ADDENDUM NO. 1

Renovation to Exterior/Interior RC Building Warrensburg Readiness Center Warrensburg, Missouri PROJECT NO.: T2306-01

May 17, 2024

FIRST FLOOR LIGHTING PLAN - BASE BID NOTES

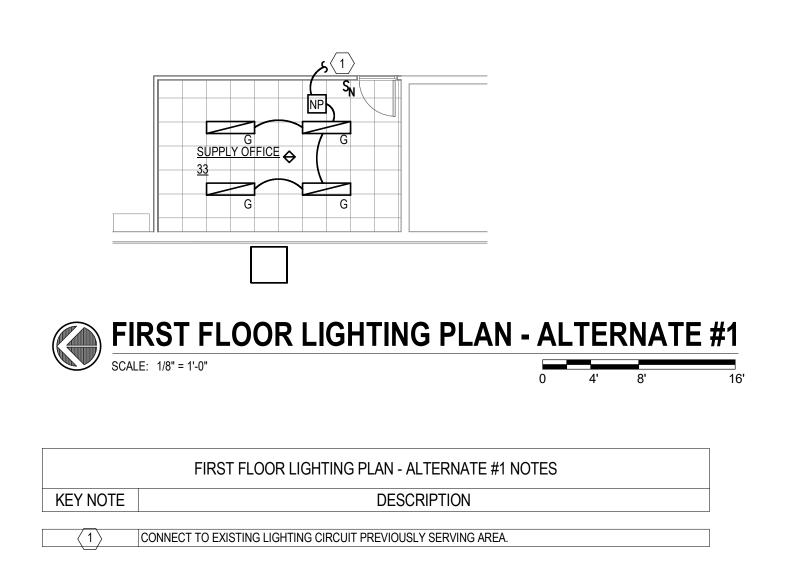
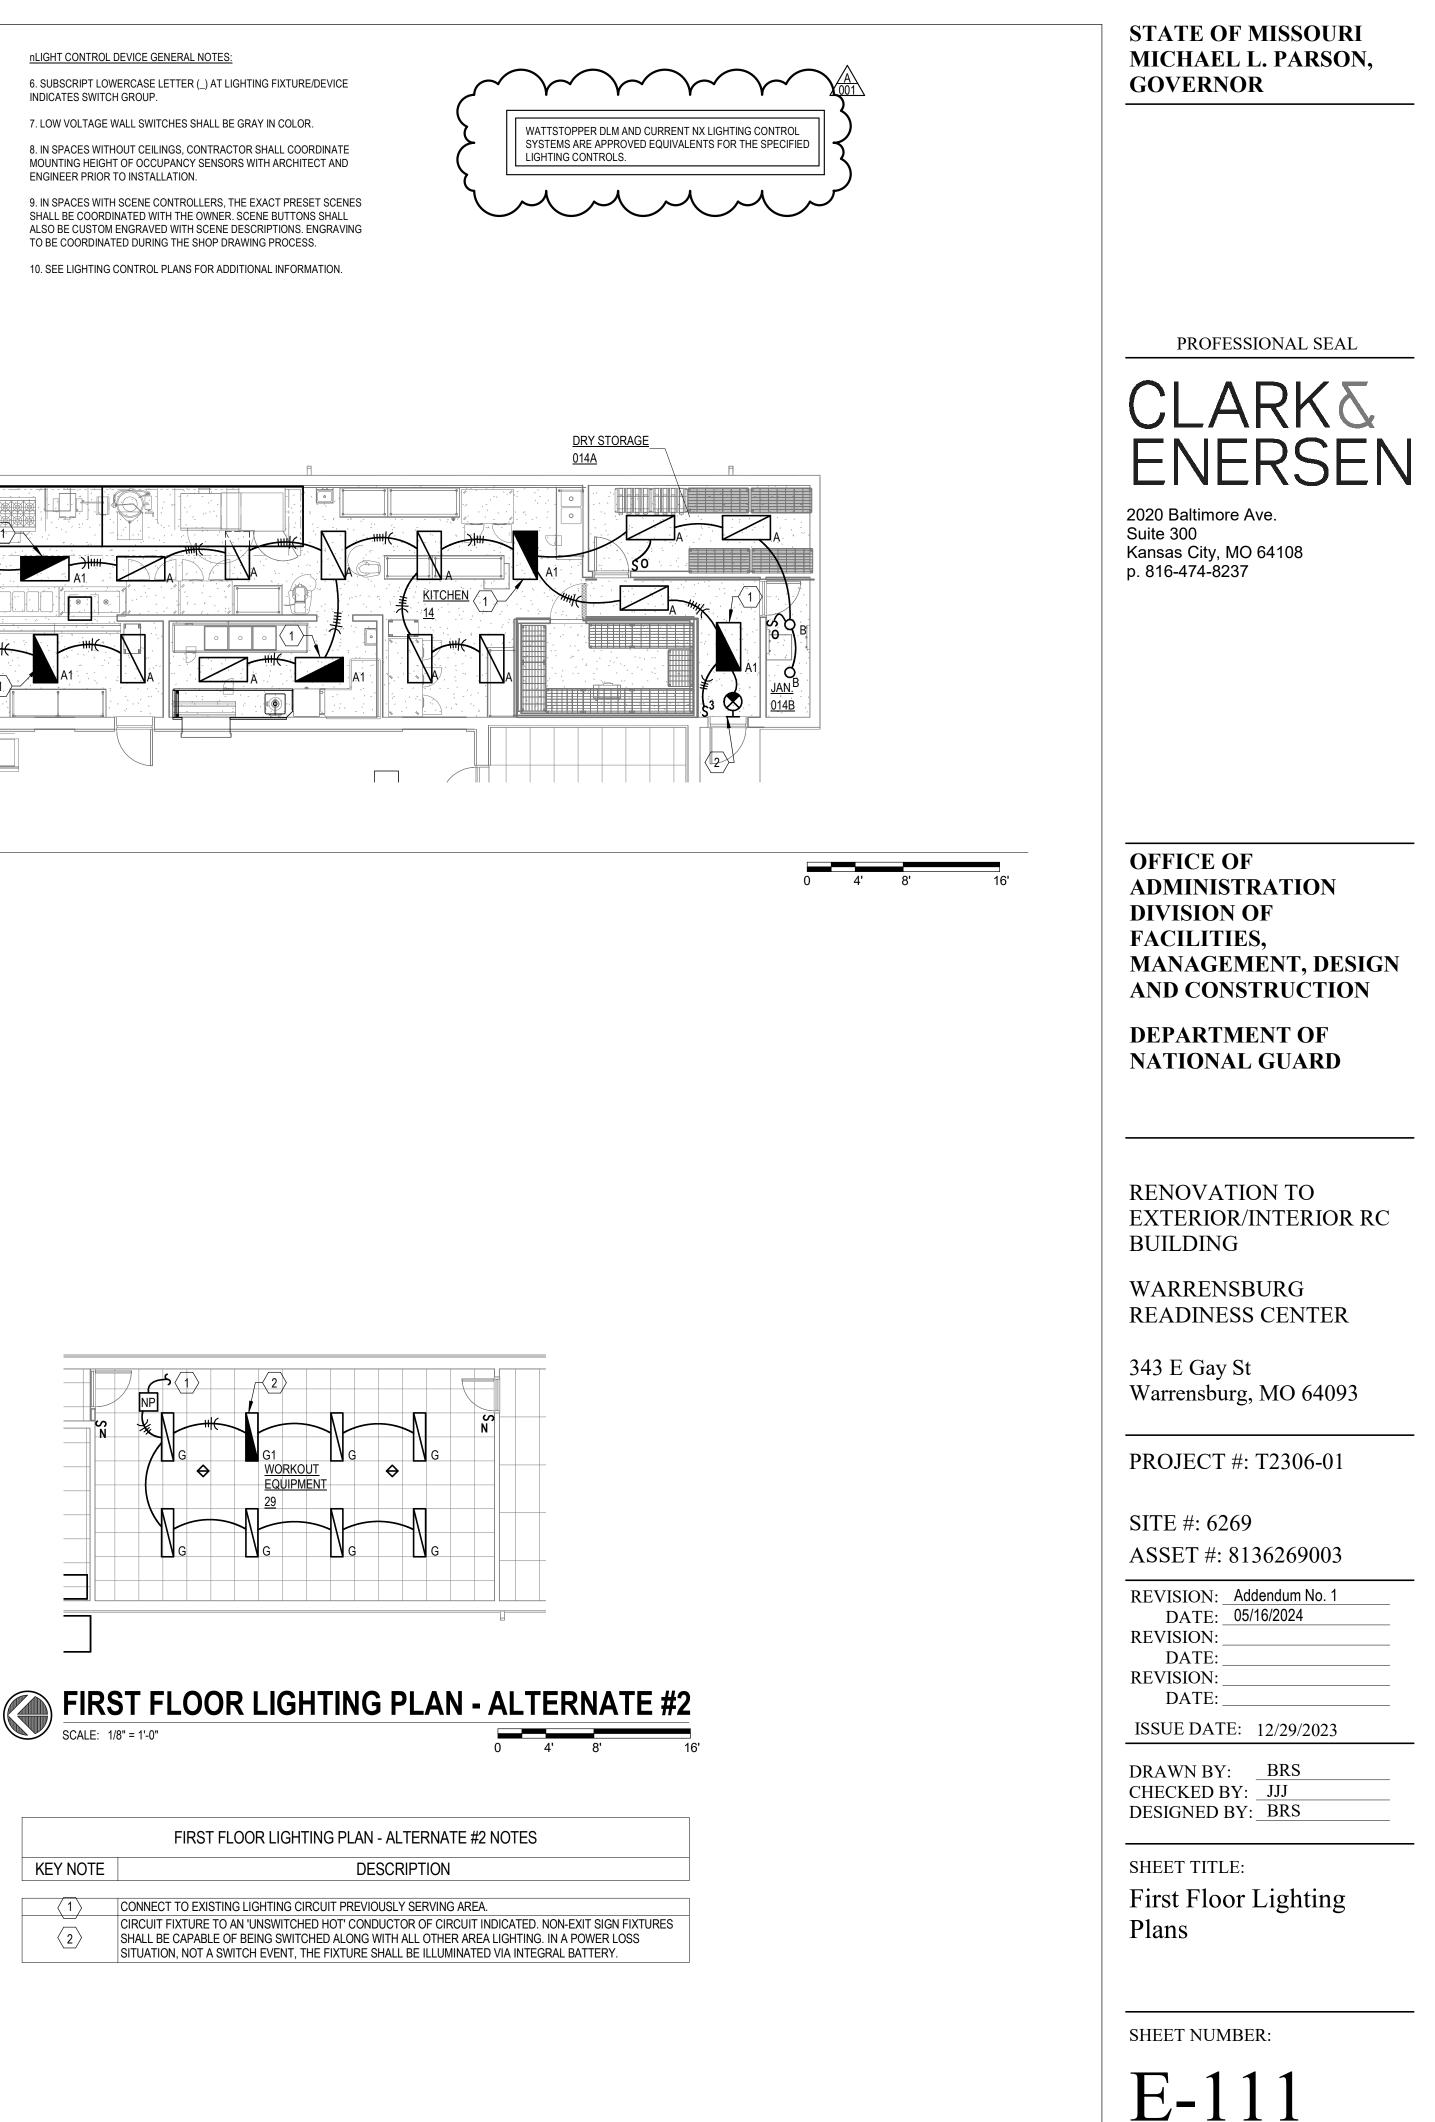
8. Sheet E-111 (attached)

- a. REVISE Exit light fixture location for exterior door in Mechanical Rm 12.
- b. ADD Note indicating that Wattstopper DLM and Current NX are approved equivalent lighting control systems to nLight which is the basis of design.

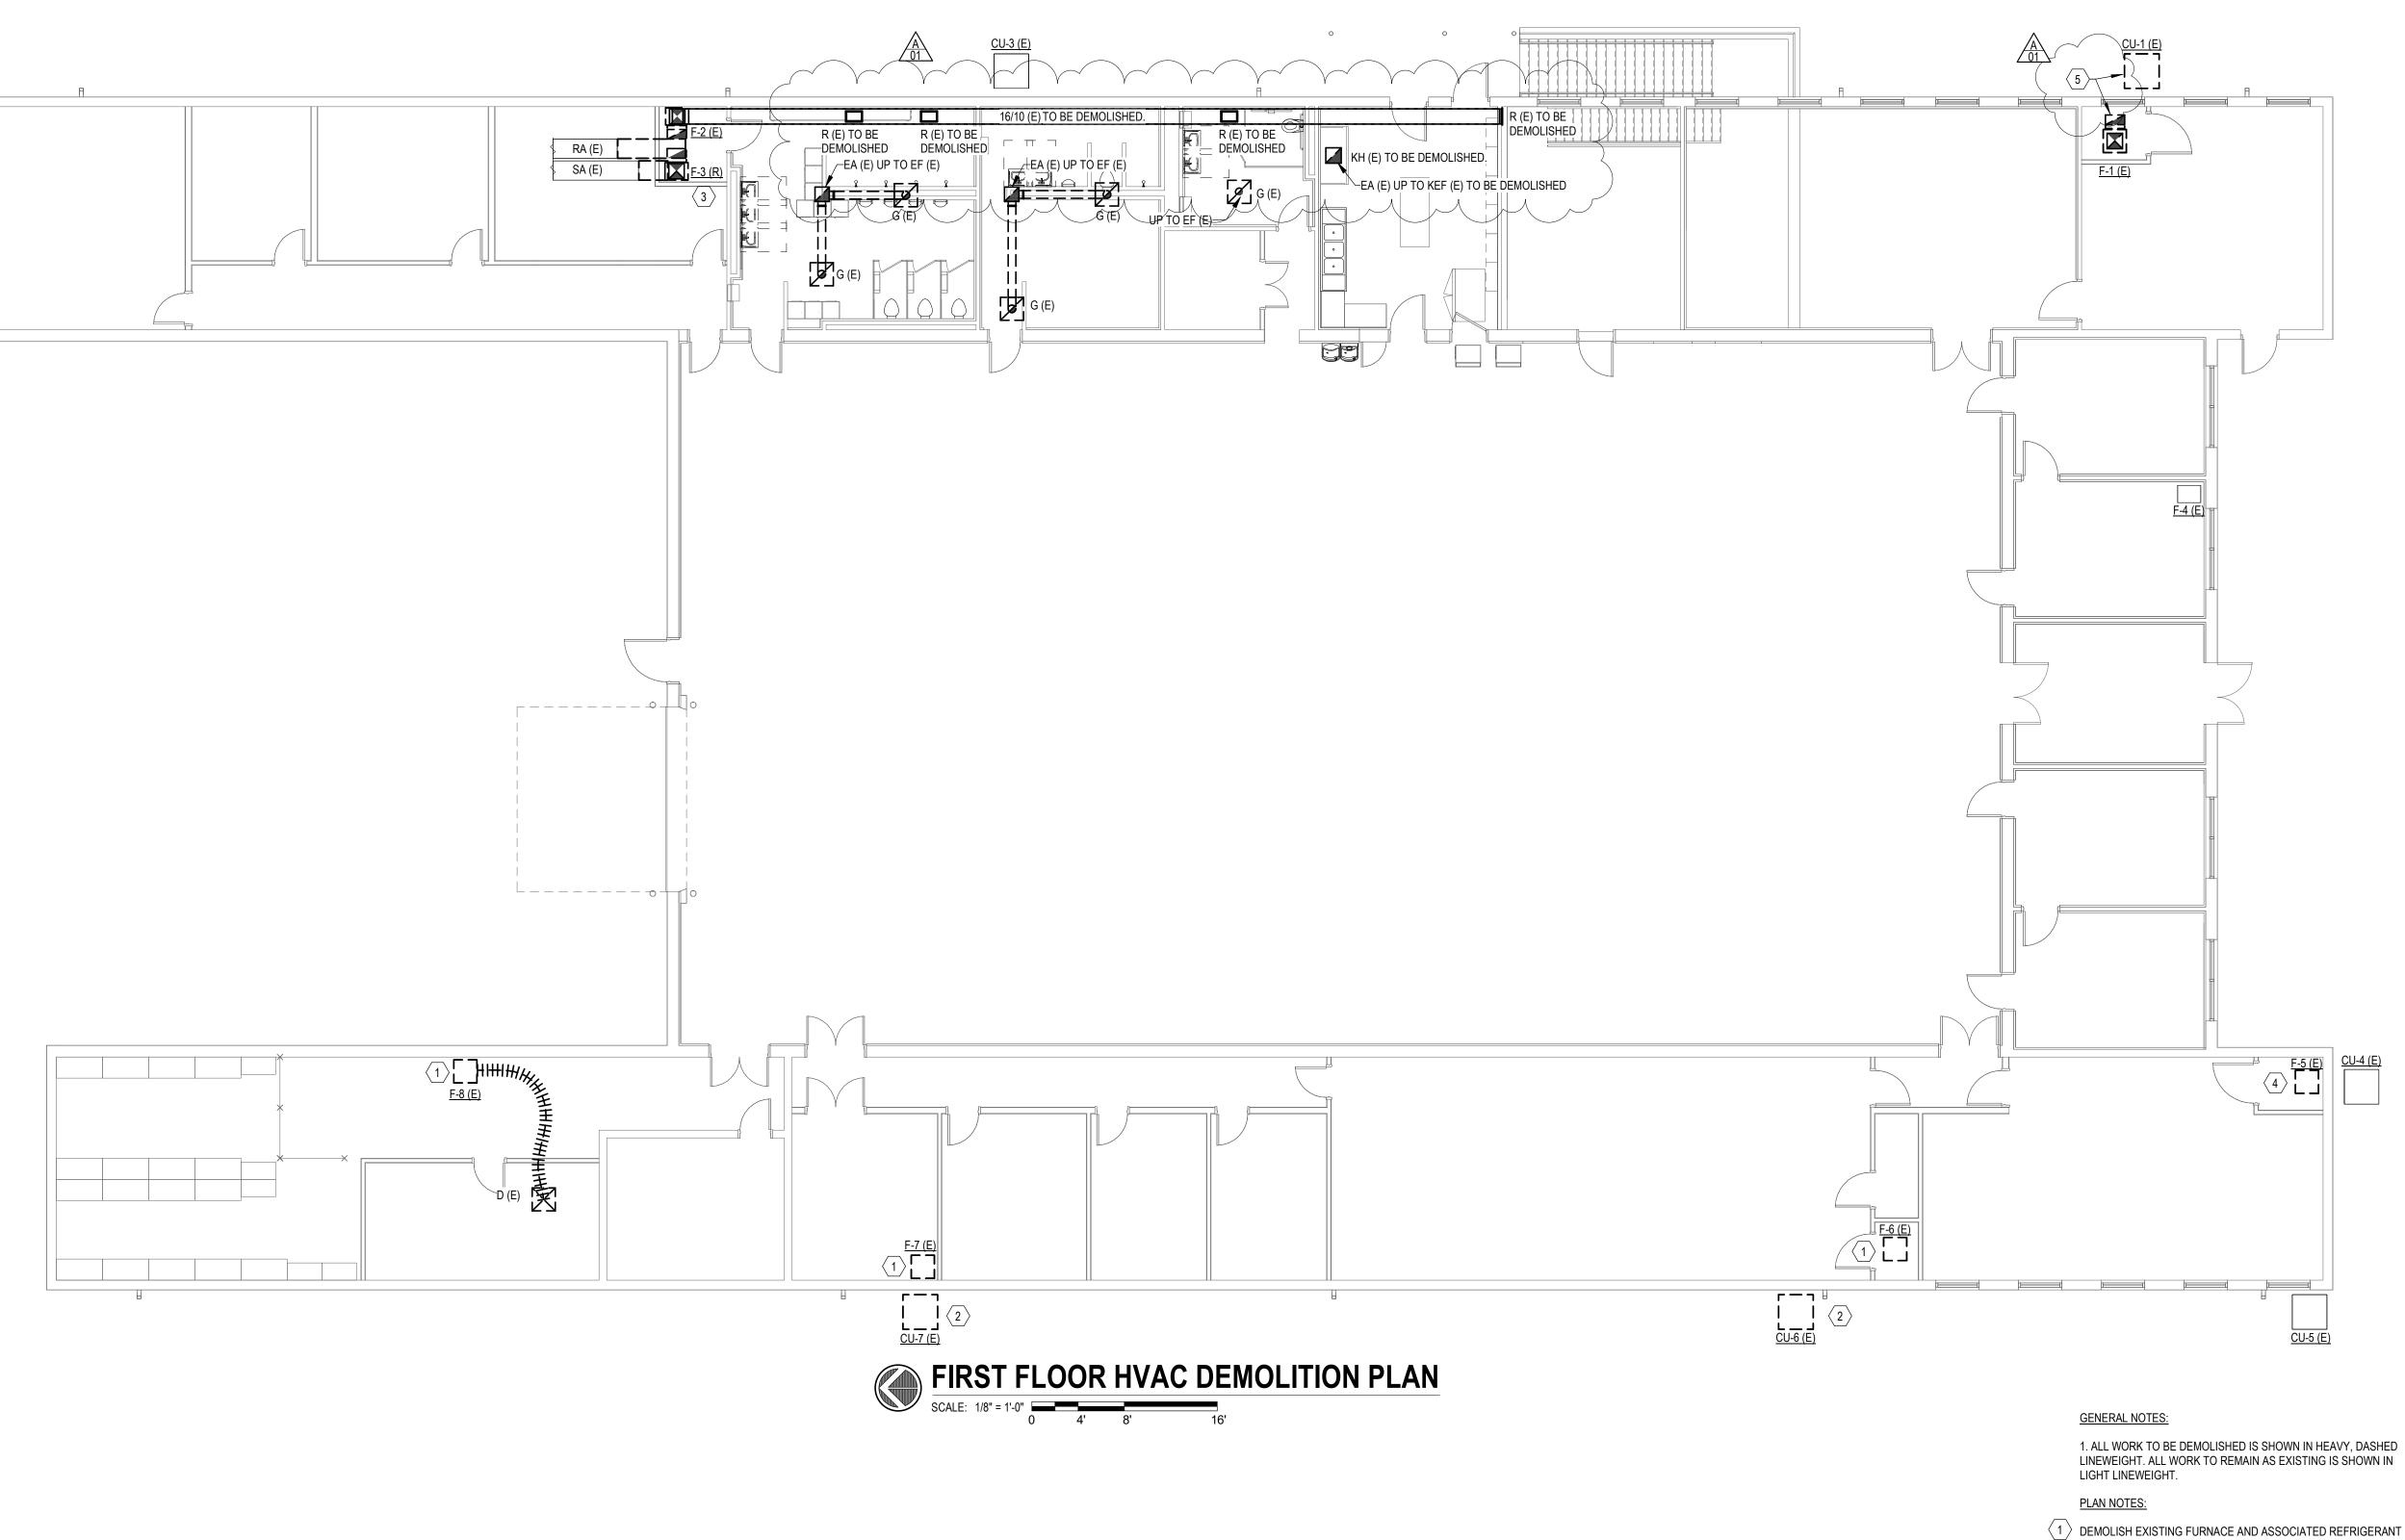
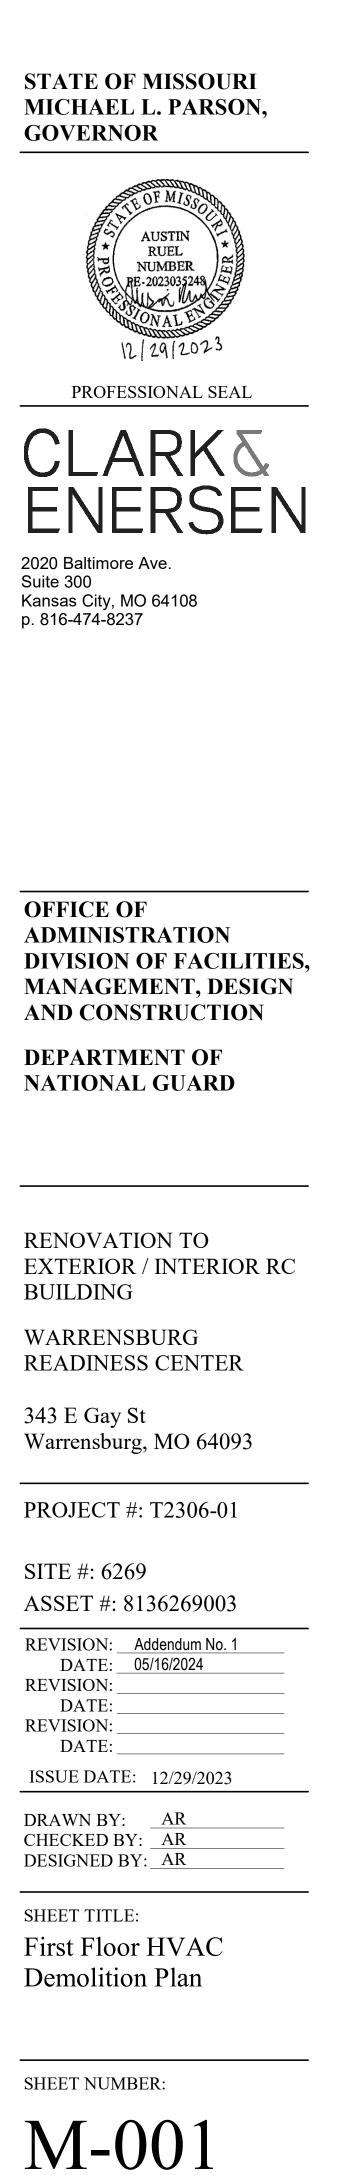
10. Sheet M-001 (attached)

a. ADD Note to existing ductwork, grilles, and hoods to be demolished for clarification due to graphical issues.
